**Drainage Review: SR 29 from SR 78 to US 27**  
**Financial Project ID: 1939572-2-52-01**  
**Reviewer: H. Dan Thomas (PBSJ)**  
**Date: April 8, 2004**

**S.R. 29  
STUDY**  
West of Chaparral Slough  
Glades County, Florida

**EXISTING DRAINAGE PATTERNS**

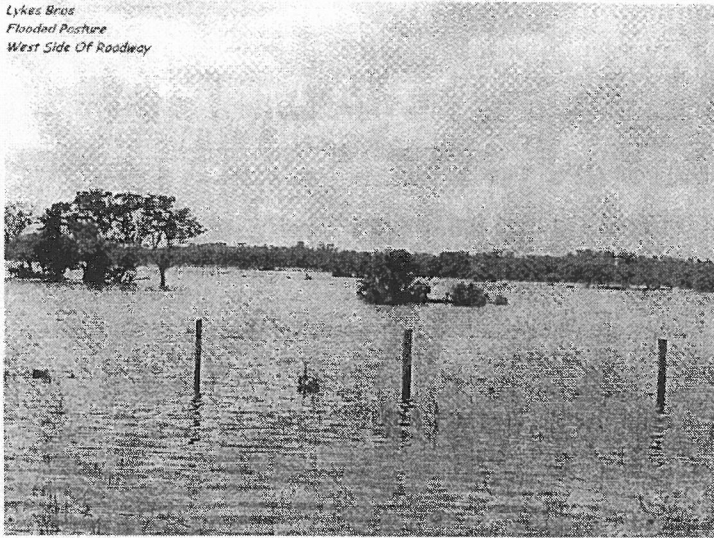
The discharge and stages in the Parson's report are suspect as there is significant storage upstream from the structures between bridges 05035 (Lone Pine Creek) and 050033 (Chaparral Slough) which was not accounted for in the stormwater model run.

In order to adequately assess the size and number of structures needed to bring the highway up to current standards, an extensive amount of survey information will be needed. It is suspected that the drainage basin for Chaparral Slough is overtopping and entering into the Lone Pine Creek Basin. Survey data will also be necessary to determine the reason for the high tailwater being observed at the Chaparral Slough and Lone Pine Creek bridges and is assumed to be caused by downstream obstructions. Lone Pine Creek drains into a wetland area downstream of SR 29 prior to draining into Deadmans Branch and into the Caloosahatchee River.

The flooding area at the triple 30 inch cross drain is located within a low area in the pavement grade between the Lone Pine Creek (Bridge 050035) and Chaparral Slough (Bridge 050033) bridges. It is not cost effective to either raise all of the SR 29 grade or to replace the existing cross drains within the limits of this project in order to bring the highway up to current design standards, and the Department has proceeded with its resurfacing contract on SR 29 without replacing the existing cross drain structures. It is recommended that the grade in the vicinity of the existing triple 30 inch cross drain at station 356+15 be raised to an elevation of 35.7 feet (USGS '29 Datum). The result of raising the grade from sta. 336+00 to sta. 372+00 will force more of the stormwater runoff to the southwest to Lone Pine Creek and minimize the frequency of the flooding of the southbound SR 29 lane.
